SECOND FIVE-YEAR REVIEW

**MALLORY CAPACITOR CO. SITE
WAYNESBORO, TENNESSEE**

**Prepared For:
Battery Properties, Inc.**

**JUNE 2003
REF. NO. 2319 (48)**

Figure 3. Recommended well locations for the shallow zone.

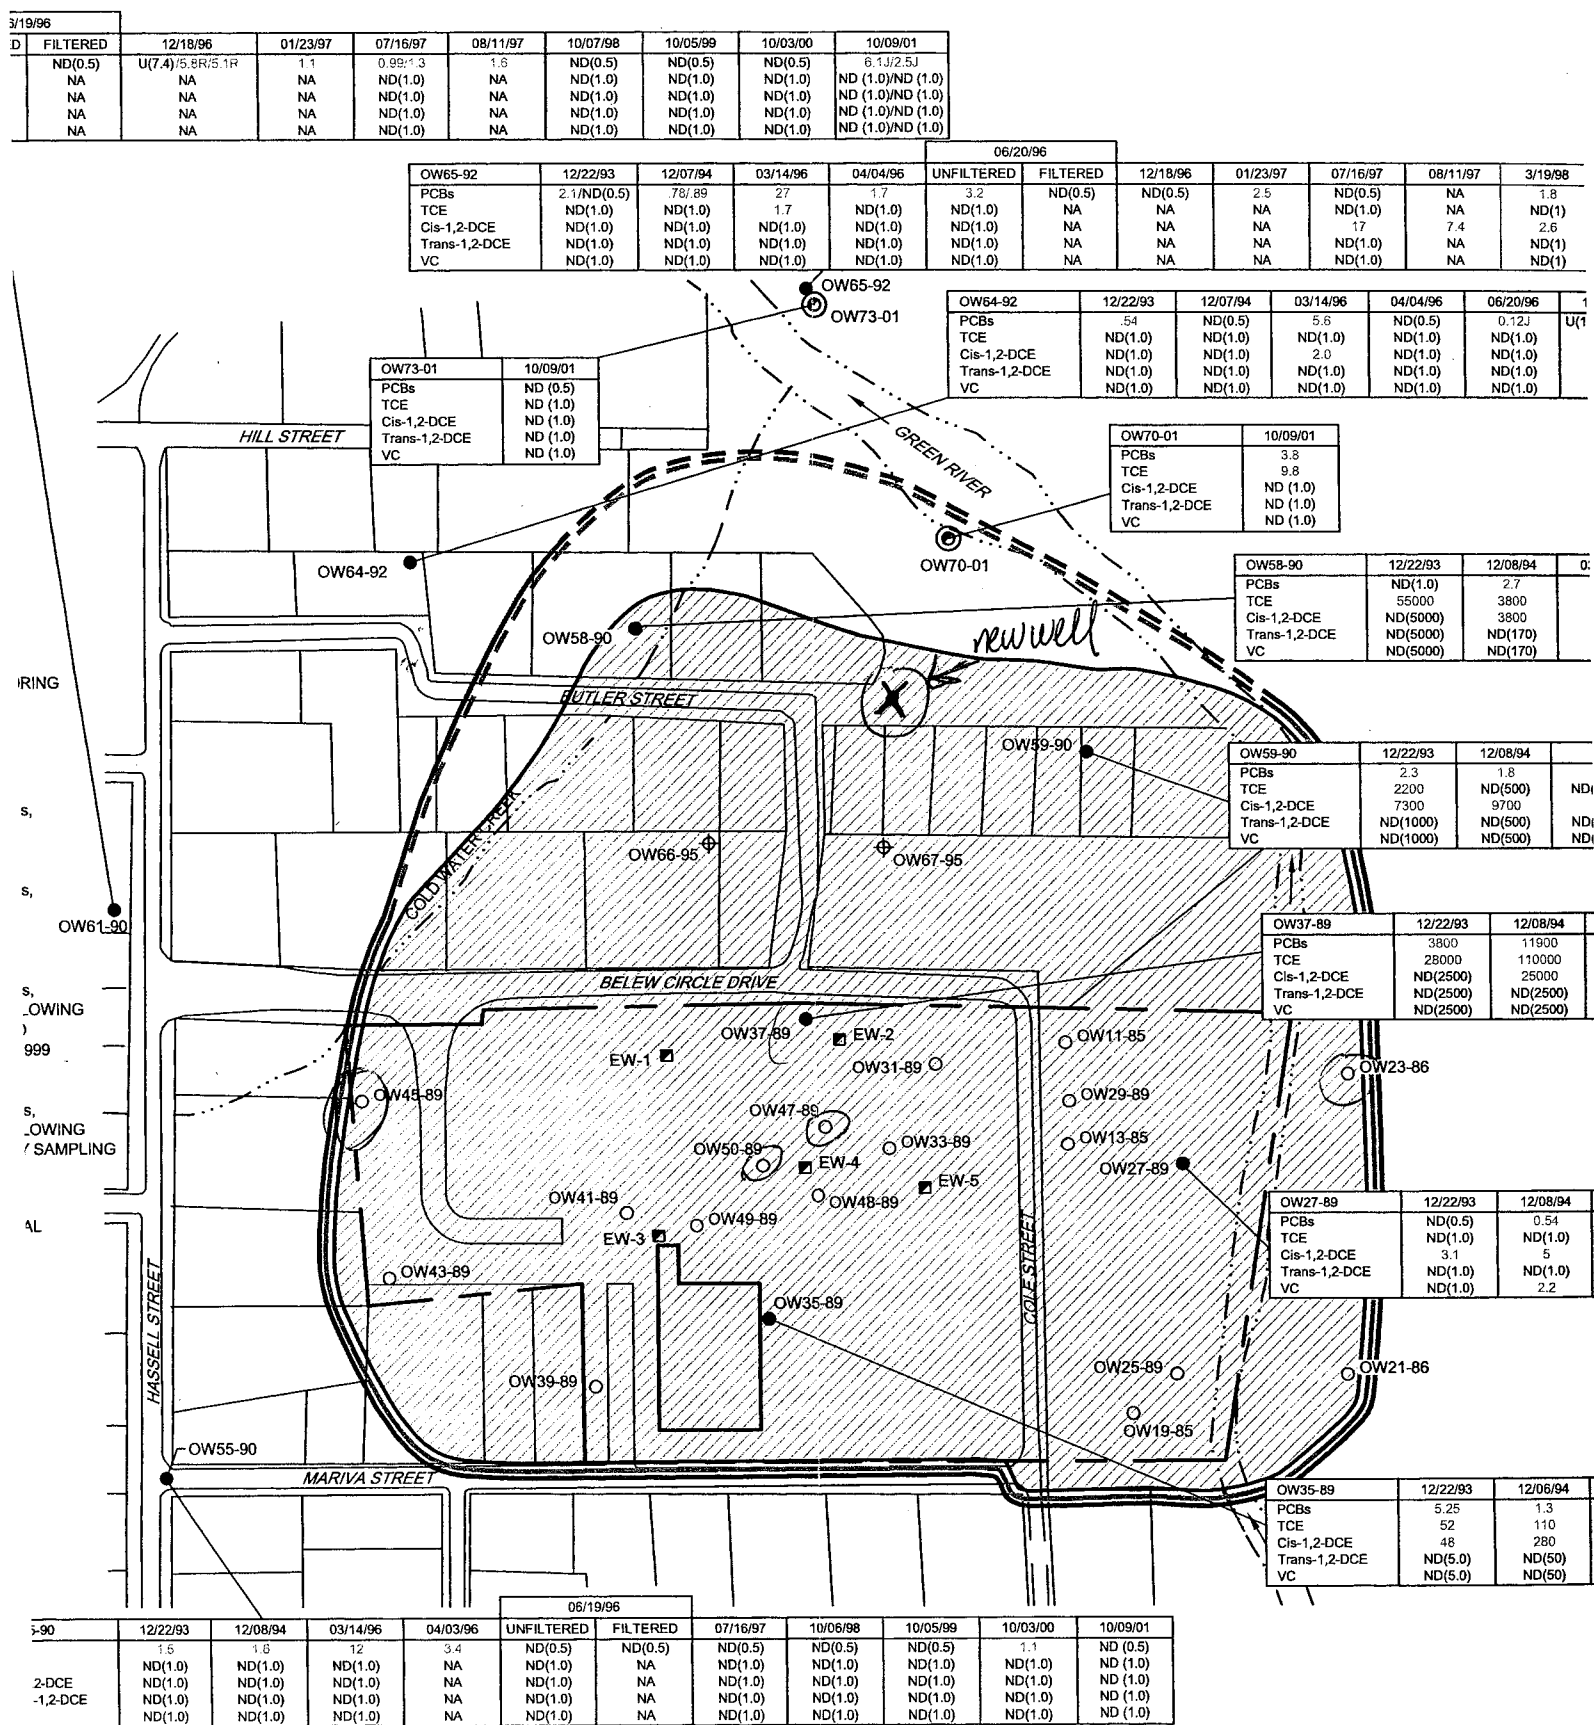
The upgradient area is loosely defined as that area west and south, and in general, upgradient of the source area. Currently the monitoring locations in the shallow aquifer are well outside the contamination plume. In the shallow aquifer, it is recommended that well OW45-89 be included in the monitoring program because of its proximity to the presumed plume boundary as drawn in Figure 4.1 of the 2001 Annual Report. As in the eastern area, monitoring at this location can assist in the evaluation of the effectiveness of the source area actions described above. In the deep aquifer, coverage on the western plume boundary is adequate, but no locations defining the southern boundary are monitored regularly. For this reason, it is recommended that well OW40-89 be included in regular monitoring. Finally, in the deeper aquifer zone, there are currently no wells in this portion of the plume. It may be beneficial to install a single well in this area (approximate location shown on Figure 5) in order to document the extent of contaminant migration in this portion of the deeper aquifer, verifying the contour lines as drawn on Figure 4.3 of the 2001 Annual Report.

new wells as shown on Figures 3, 4, and 5 be installed. These wells will provide the data necessary to evaluate the effectiveness of additional source area activities and will support the evaluation of MNA at the site.

In response to these recommendations, CRA concurred with installing a new off-Site shallow/deep/deeper bedrock monitoring well nest approximately mid-way between the existing shallow wells OW58-90 and OW59-90, considering that this monitoring well nest will improve the understanding of off-Site plume behavior and will aid in the MNA remedy evaluation for the off-Site plume. CRA indicated that, since only low VOC concentrations are detected at OW63-90, installing an additional well upgradient of OW63-90 is not warranted.

USEPA concurred with this response.

Figure 5. Recommended well locations for the deeper zone.

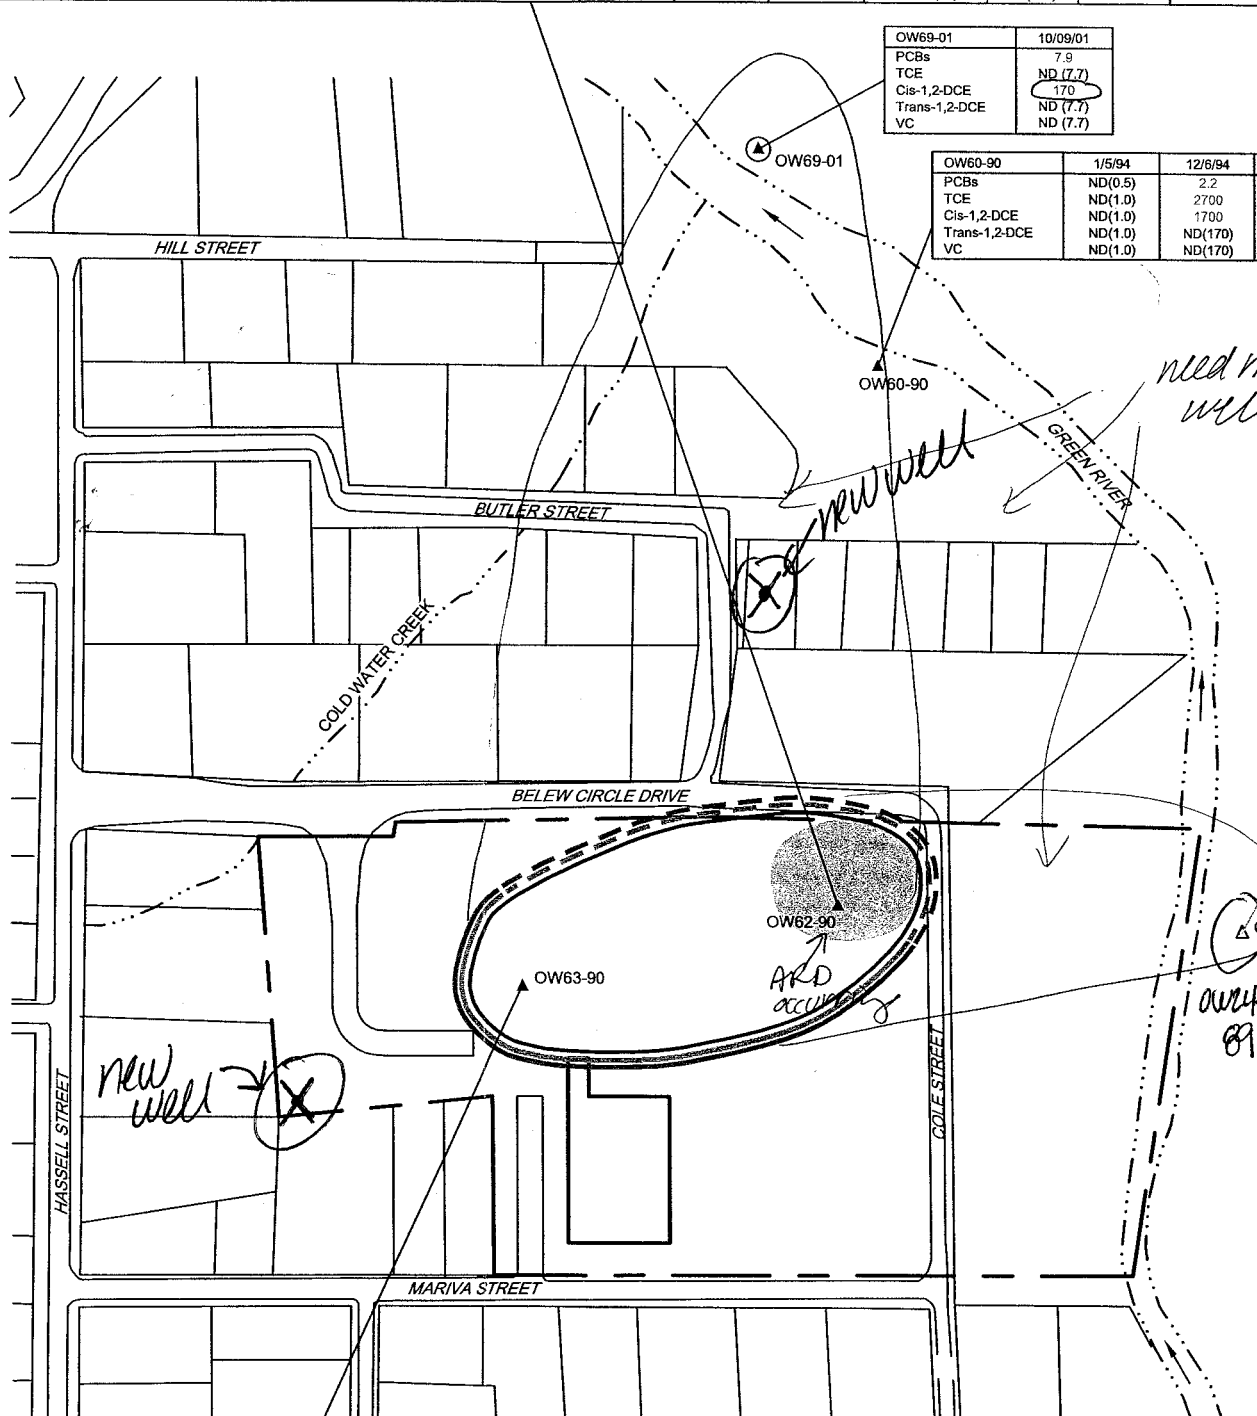
is occurring (as evidenced by cis-1,2-DCE in OW-69-01), it is necessary to document the attenuation of contaminants along the flowpath from the source area. In order to do this, it is recommended that one additional well be installed at the location shown on Figure 5.
